Final Environmental Statement

related to the operation of
Waterford Steam Electric Station,
Unit No. 3

Docket No. 50-382

Louisiana Power and Light Company

Figure 5.7 Potentially Meaningful Exposure Pathways to Humans

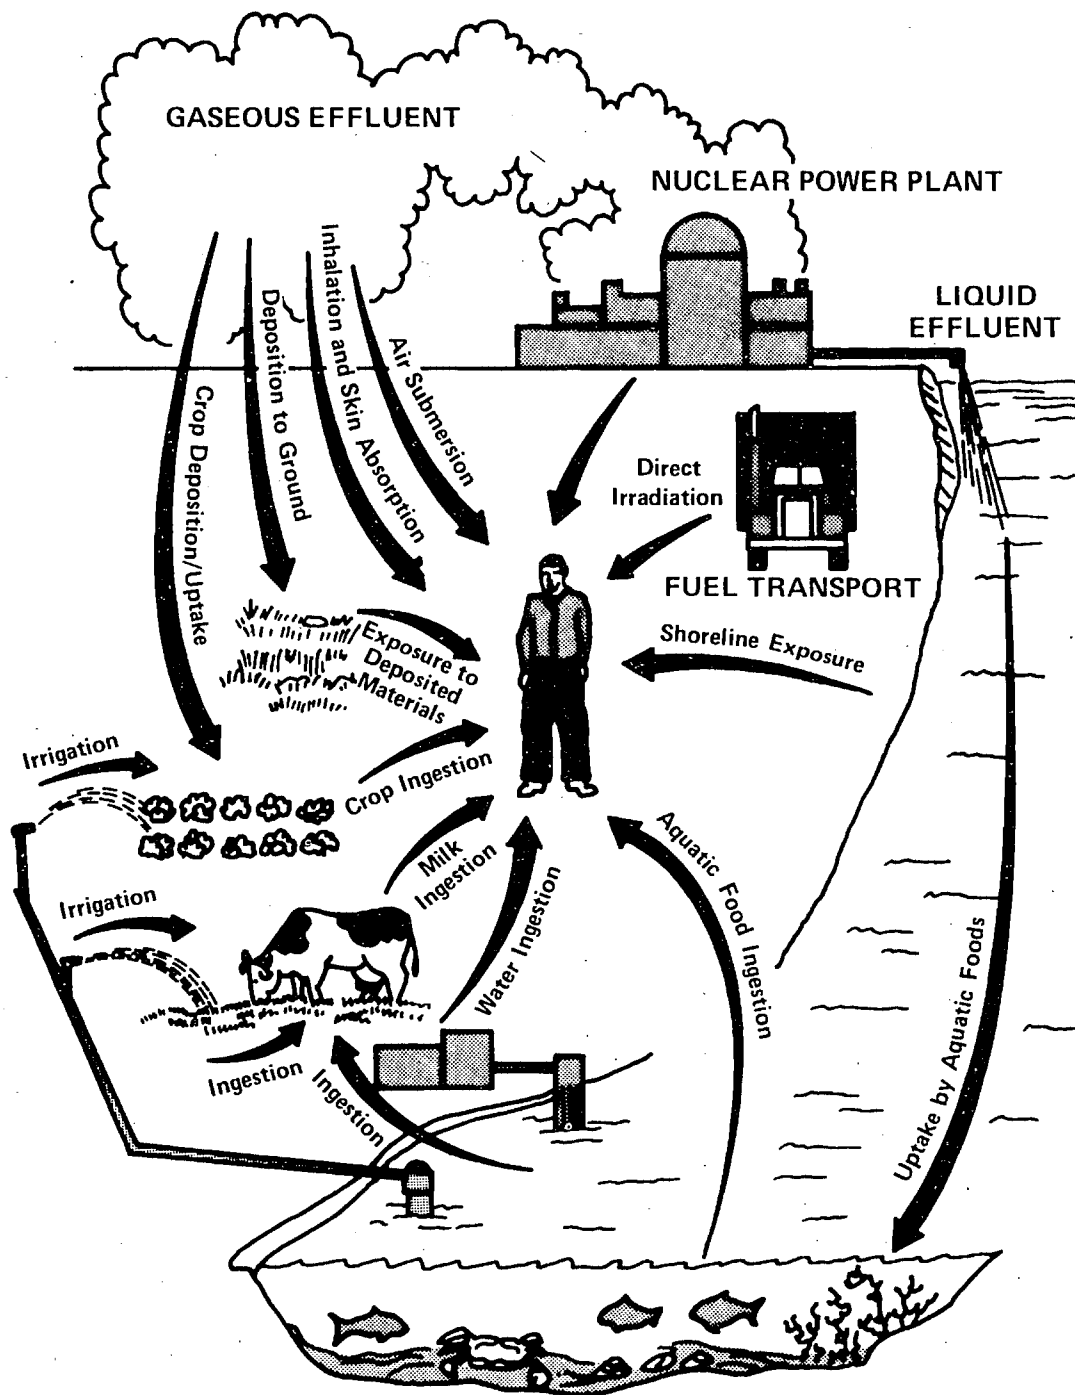
2. The environmental pathways identified in Section 5.9.1 and Figure 5.7 on page 5-27, and discussed in Appendix D, as well as pages B-61-65 of Appendix B of the Final Environmental Statement - Construction Phase, give all the possible emission pathways that could impact on the population in the environs of the facility. The dose computational methodology and models used in the estimation of the radiation doses to individuals near the plant and to populations within 80 km. of the plant have provided a reasonable estimate of the projected doses resulting from normal operating conditions as well as hypothetical accident situations at the facility. Results of these calculations have been given in Tables 5.9, 5.10, 5.11, 5.12, and 5.14. They confirm our assessment.
